ACADEMY COMPLEX RENOVATIONS

PROJECT NO. 2025-016

ADDENDUM 1

July 23rd, 2025

SCALE: 1" = 30'-0"
DATE: 06-09-25
SHEET NAME: UTILITY PLAN
SHEET NO: C400

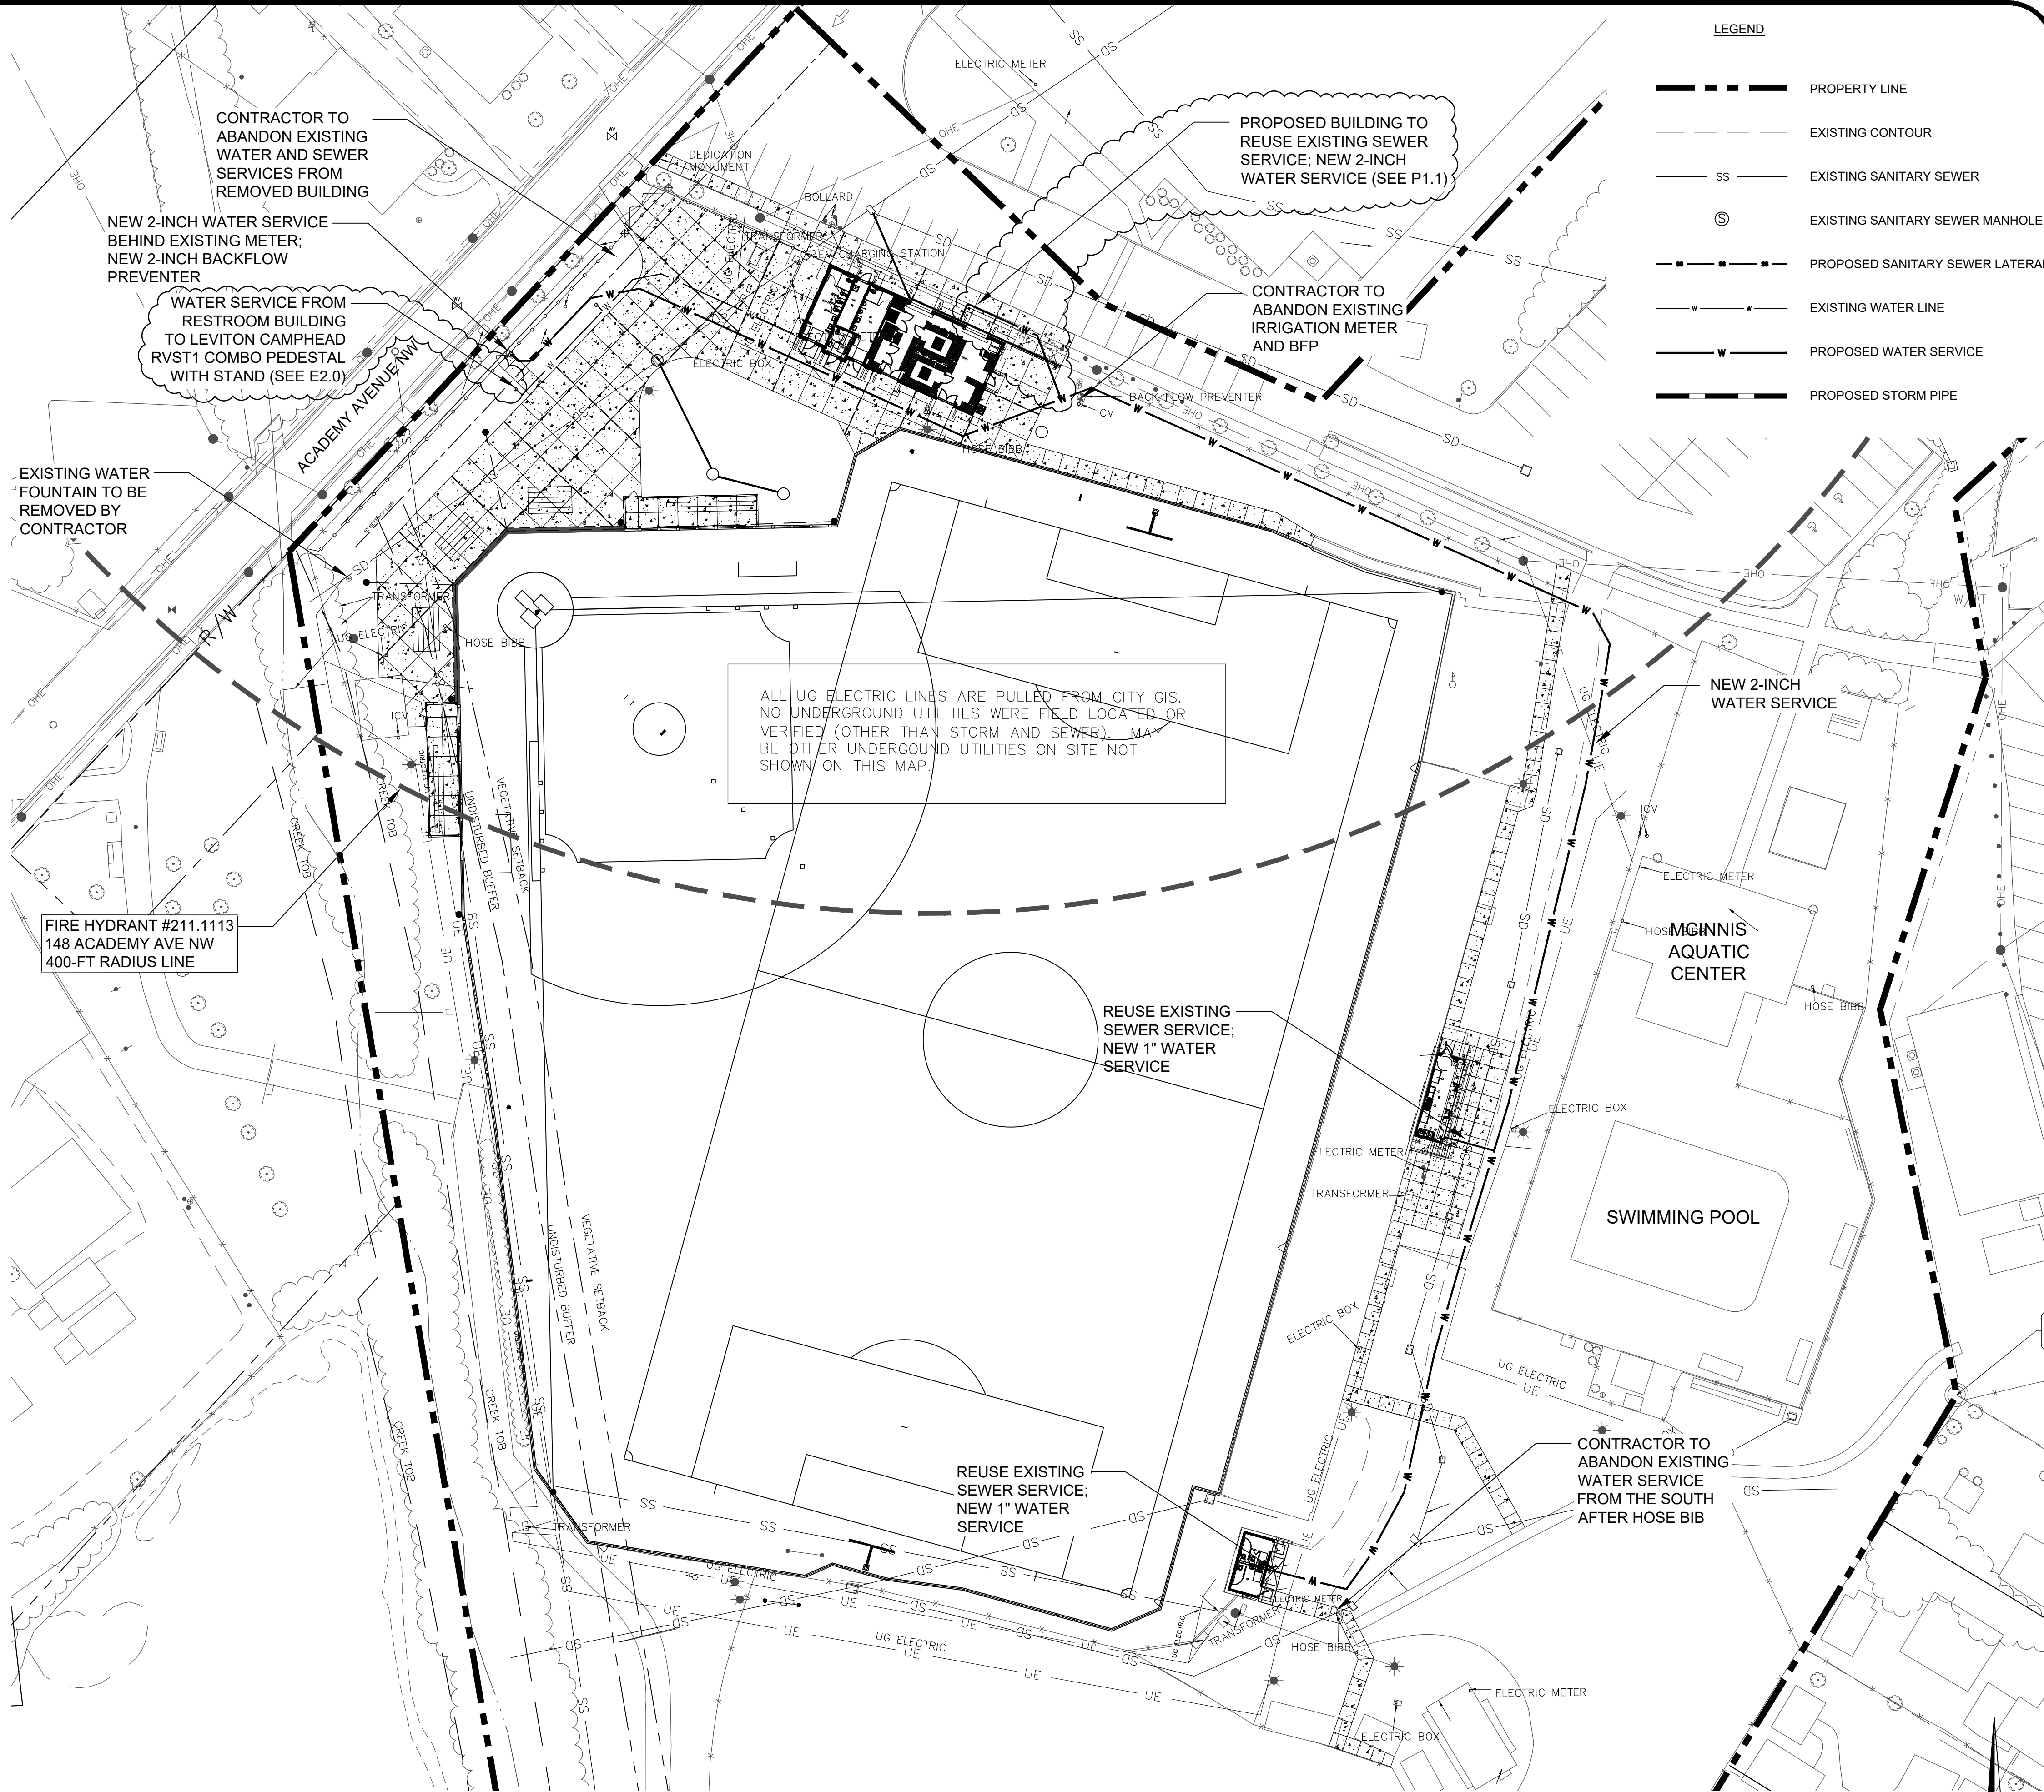
3. P1.1 and C-400 also show the waterline tying into the back side of the building, is this correct?

a. Yes, 2" water shut-off needs to be in open area between overhead doors as shown on P1.1. (SEE REVISED PLAN C400 ATTACHED).

1 ASPHALT TRAIL

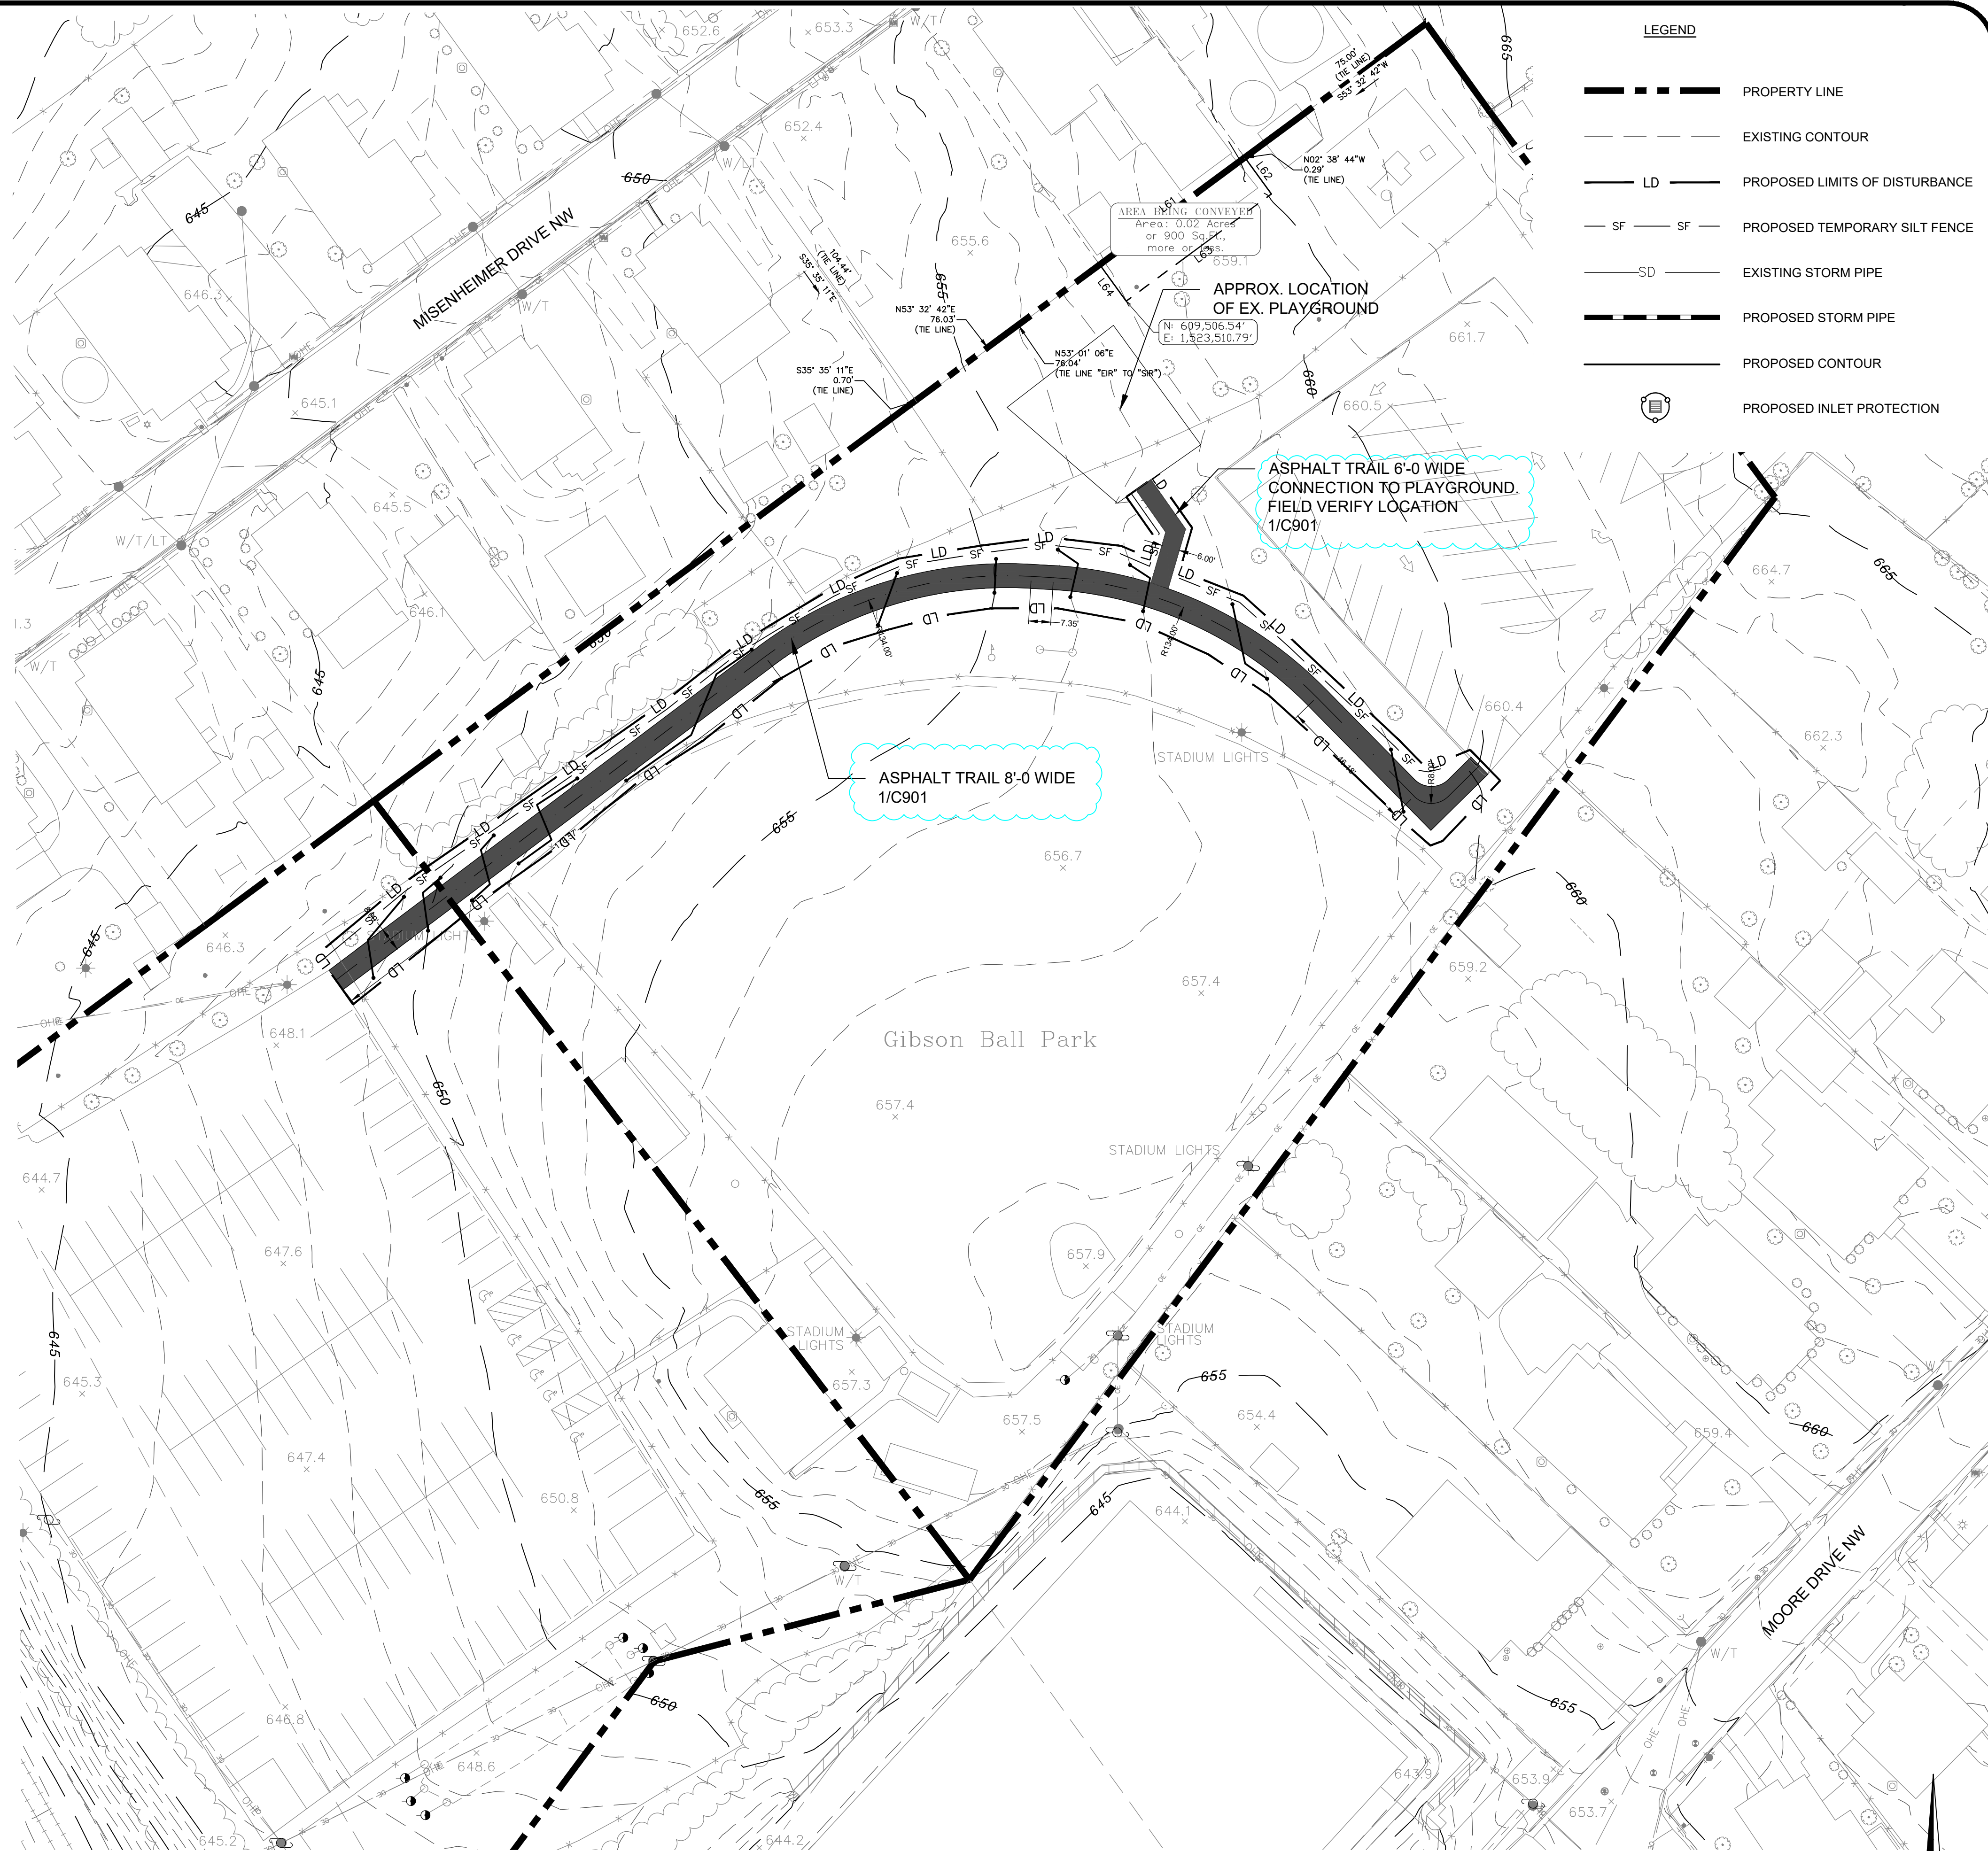
22. Asphalt trail 6'-0" and 8'-0" wide for Gibson Park states per detail 1/C200. Please clarify as there is no detail 1/C200.

- a. Please see the updated C901 sheet attached.
